Technical Note

Date: 27/10/2022
Ref: A1851 TN01
To: Adam Crews, Third Revolution Projects
From: Tony James, Consultant at Ion Acoustics
Gavin Irvine, Director at Ion Acoustics

Newfields Farm BESS – Response to EHO Comments – Ref: smd/2022/0180

Figure 1 – Proposed new Acoustic Barrier at 3.5m

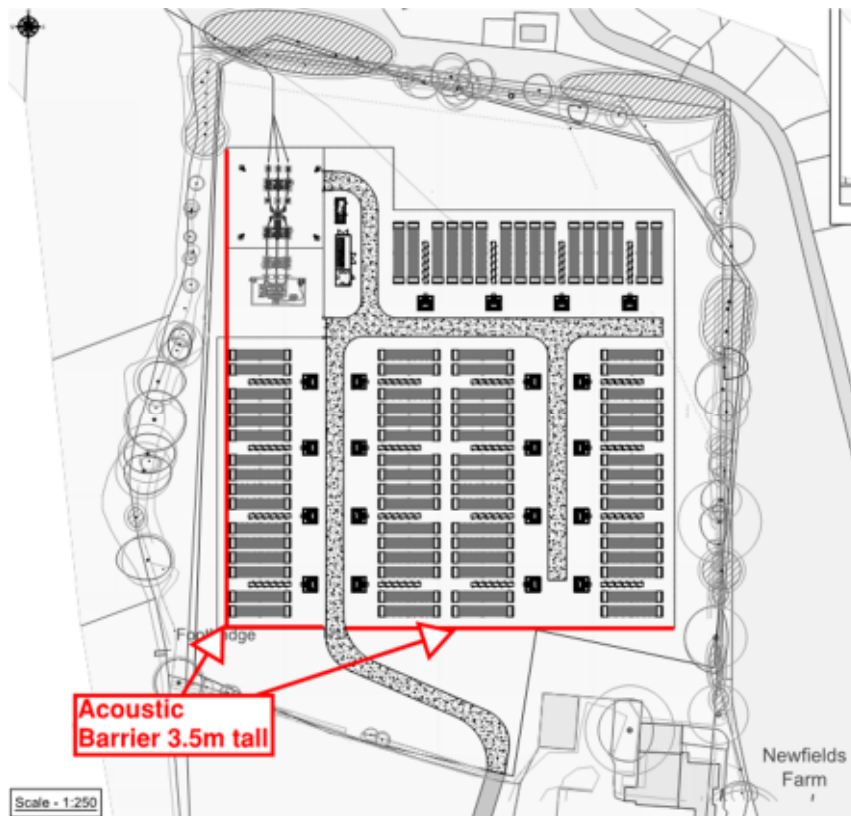
The EH response agreed with the approach during the day, however proposed a more onerous limit of parity with the background noise limit during the night. This would result in a limit at receptors AP01-02 of 30 dB L_{Ar} during the night.

The calculated rating level at AP1-2 in Ion Report A1851 R01A was 35 at AP1 and 34 at AP2, and therefore the mitigation measures have had to be reviewed to meet the more onerous night limit.

To meet the new night limit it is proposed to amend the acoustic barrier only, with all other aspects remaining as specified in A1851 R01A. The newly proposed barrier would be amended in location, to run along both the west and south BESS boundary (except for a vehicle access road) and would need to be increased from a height of 3.0m to 3.5m. The new barrier has been indicated on Figure 1 below:
